RE: ADDENDUM #1

PROJECT: Becker County Highway Department Facility
Phase Two

OWNER: Becker County, MN

ARCHITECT: OERTEL ARCHITECTS, LTD.

A1.1

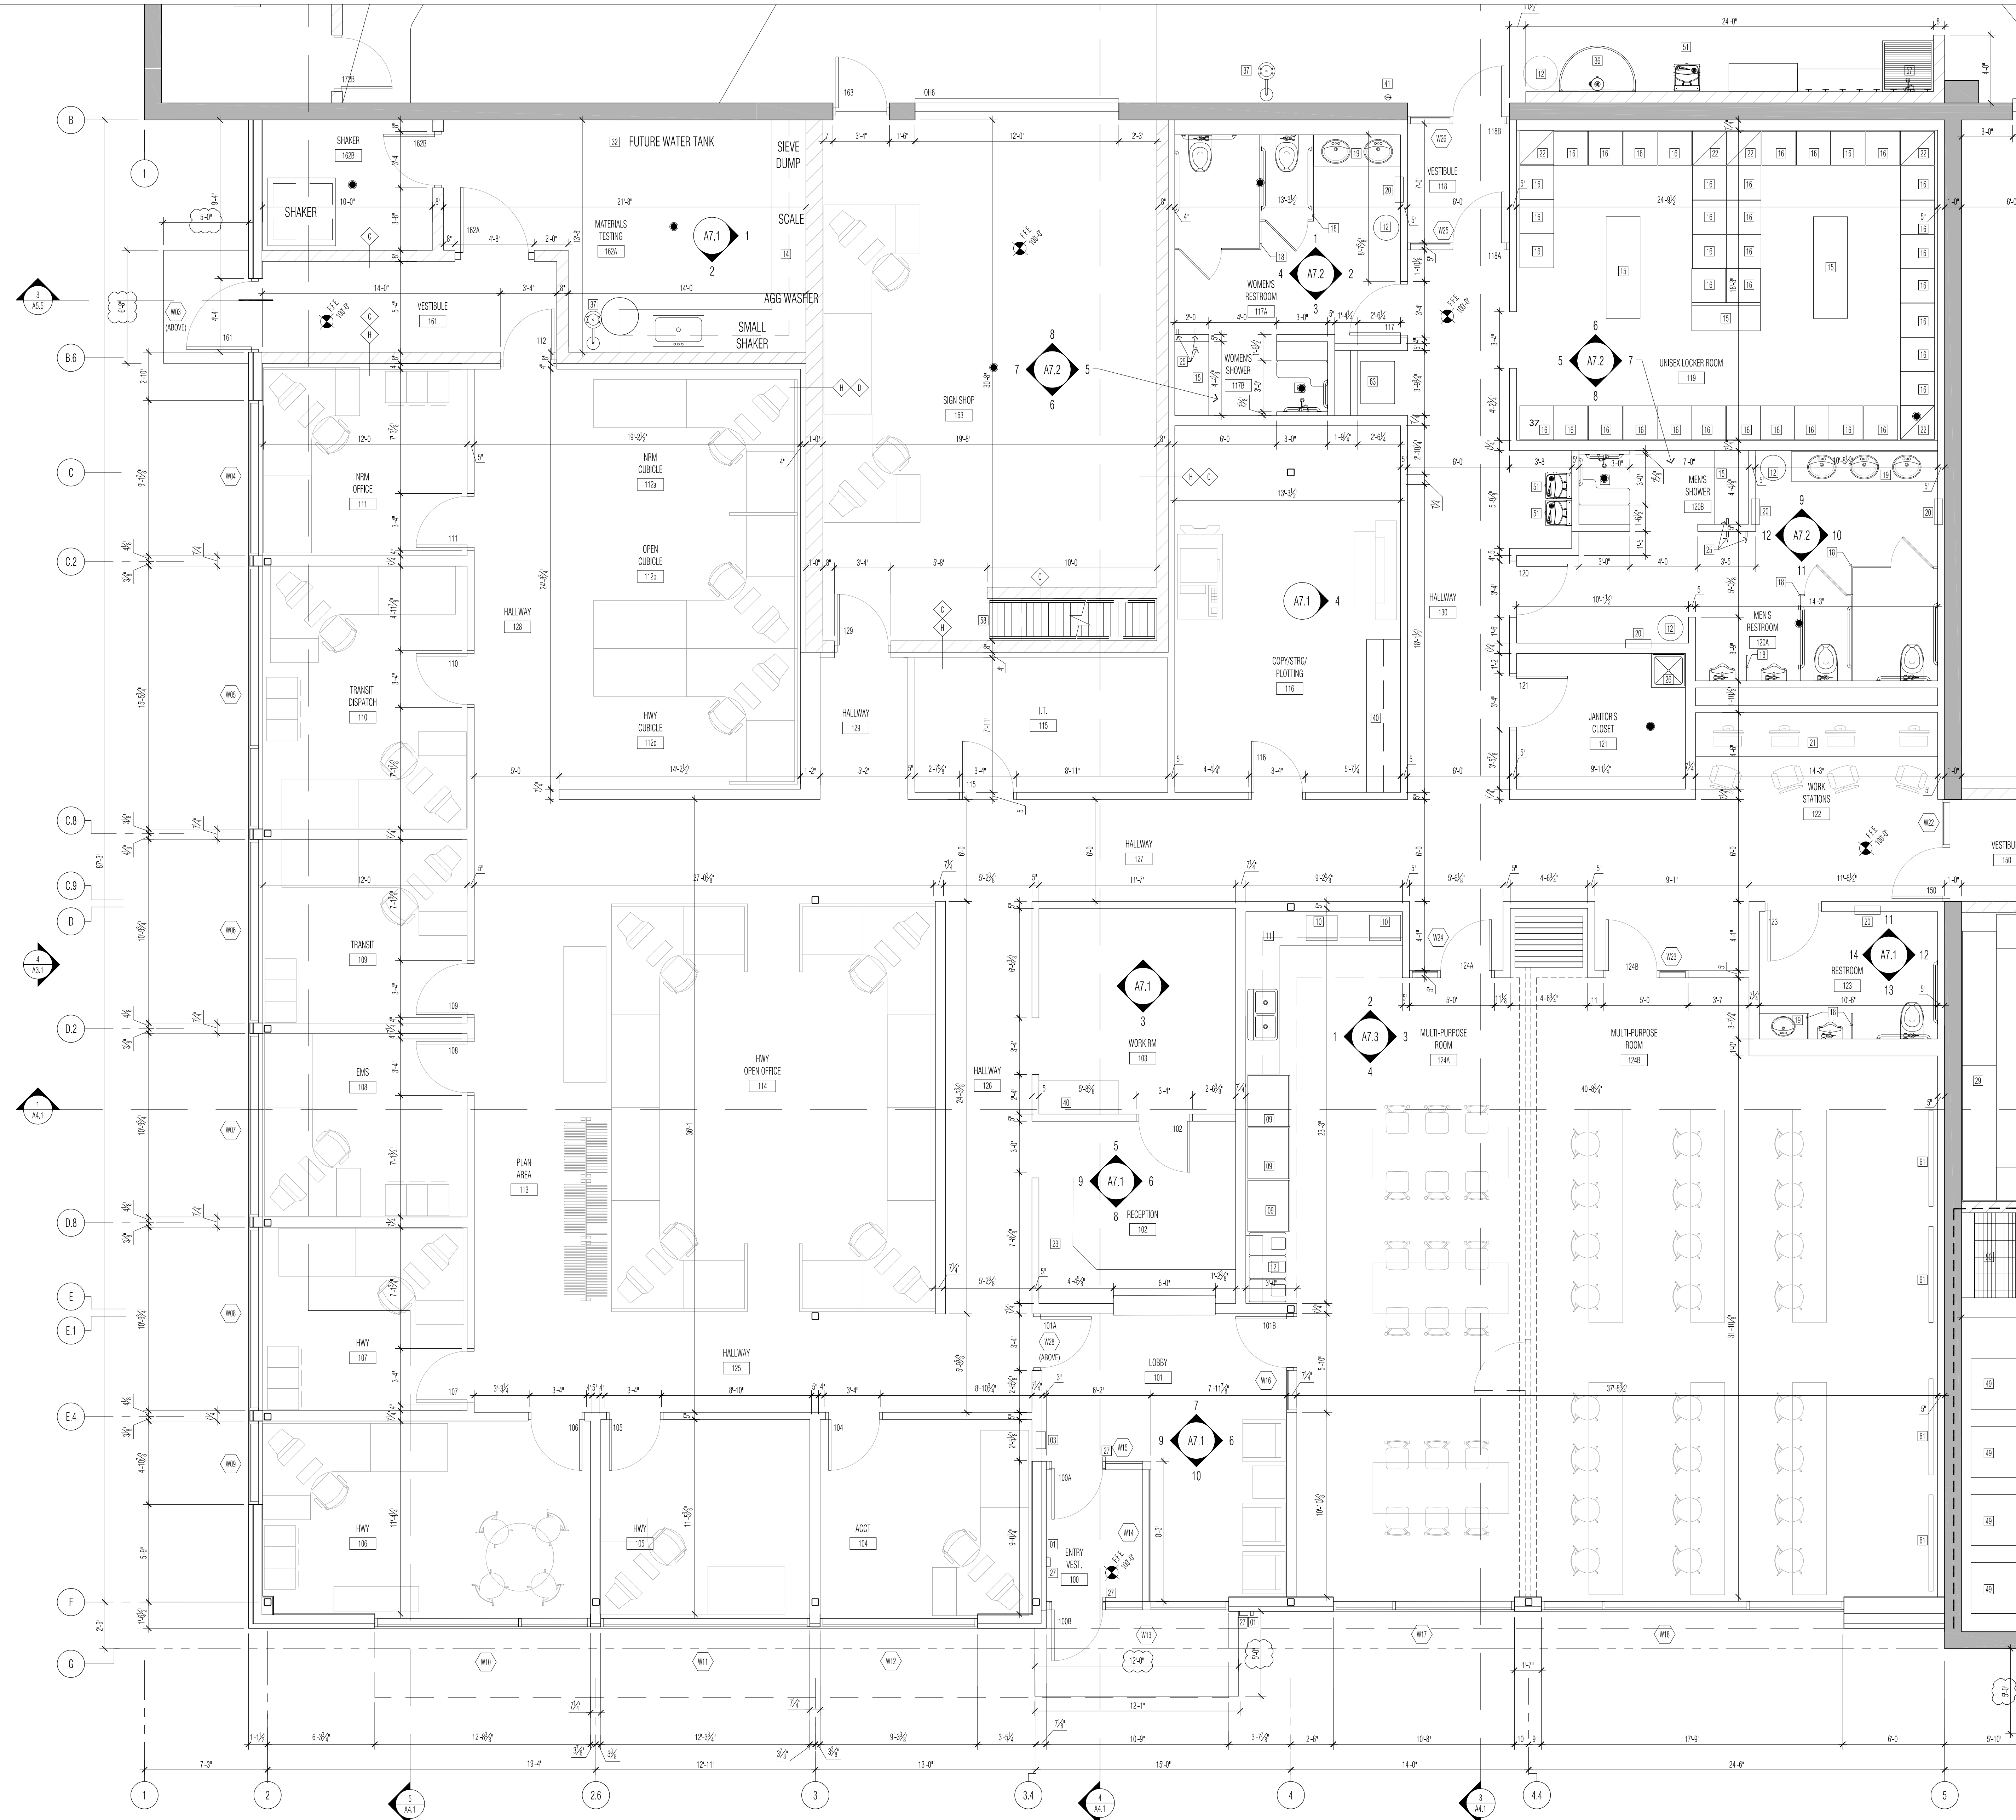
1. **A1.1, A1.2, A1.3 Building and Partial Floor Plans.** Dimensions for stoops have been added to Architectural plans for accessibility code compliance. Disregard dimensions noted on S1.1 and S1.2.

2. **A1.1 Building Plan.** The quantity of steel supports for the shelf mezzanine along the north wall (grid A) has been updated to match that shown on structural. See S1.3 for actual dimensions/locations of supports.

3. **A1.1. Building Plan.** Add (3) bollards at vehicle wash equipment area. 6" diam, 4' high, bolt-down.
4. **A5.2. Details 1 and 2.** Parapet Ladders. All steel to be galvanized. Treads and intermediate landing to be open grating as noted.

1 EMBEDDED WELDING ANCHOR PLATE
1 1/2" = 1'-0"

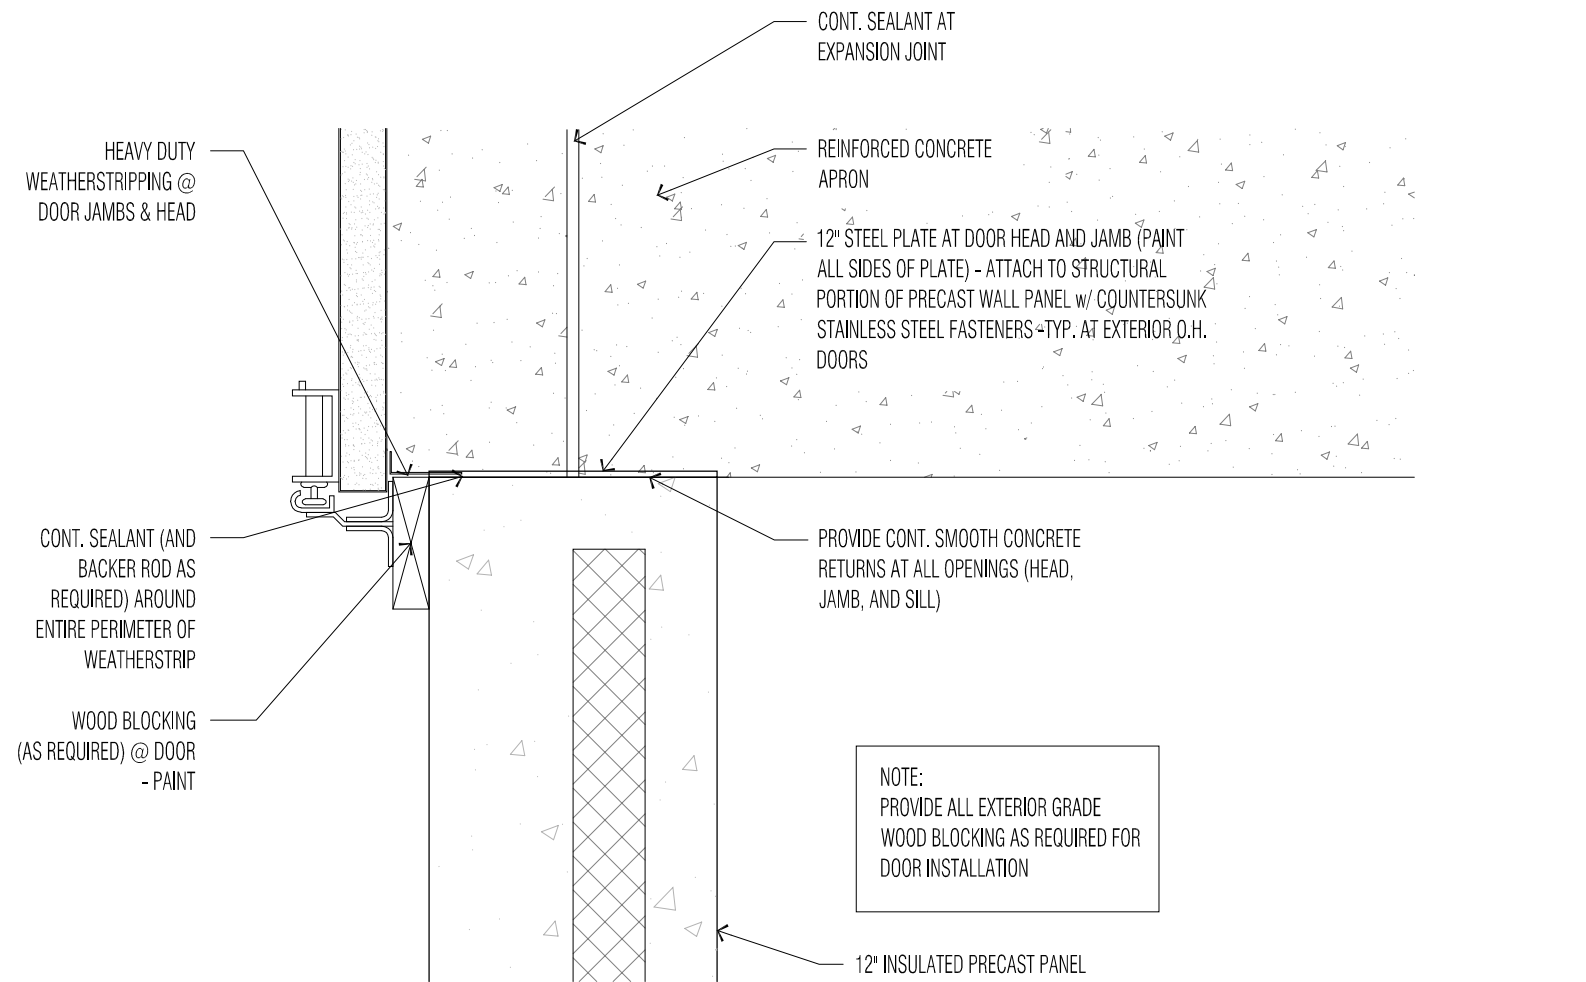
5. **A6.1 Details.** Add sheet in its entirety. Details include:
 1. Weld plates at the vehicle maintenance floor, and
 2. Steel plates at the overhead door surrounds.
